October 31, 1979

Subject: Arkansas Nuclear One-Unit 1
Docket No. 50-313
License No. DPR-51
Auxiliary (Emergency) Feedwater
Control System
(File: 1510.1)

FIGURE 1

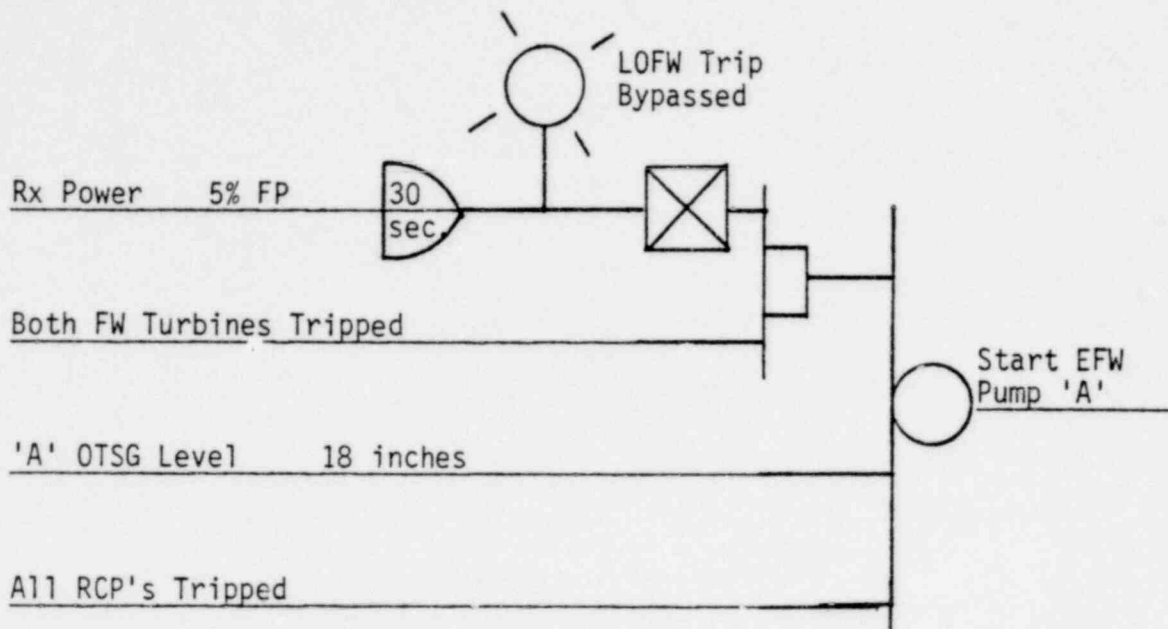
Figure 1 shows the initiation logic for Train A (NNI-X). This logic will be duplicated in NNI-Y for Train B. The associated EFW train will automatically start whenever one of three conditions exist:

- loss of both mainfeed pumps
- loss of all four reactor coolant pumps
- low level in the associated steam generator

Train A initiation will result in opening signals being supplied to turbine steam supply valves CV-2617 and CV-2667. Train B initiation will result in a start signal being supplied to motor-driven pump P7B. Control of EFW flow will be identical to the present ICS control scheme except that CV-2670 will be controlled by NNI-X and CV-2620 will be controlled by NNI-Y.

The automatic initiation on LMFW will be automatically bypassed when Reactor Power is less than 5% FP and the bypass will be automatically removed when Reactor Power is greater than 5% FP. An annunciator output is provided for "LMFW TRIP BYPASSED" whenever Reactor Power is less than 5% FP. The automatic initiations due to loss of all reactor coolant pumps or low level in the steam generator do not have a bypass feature.
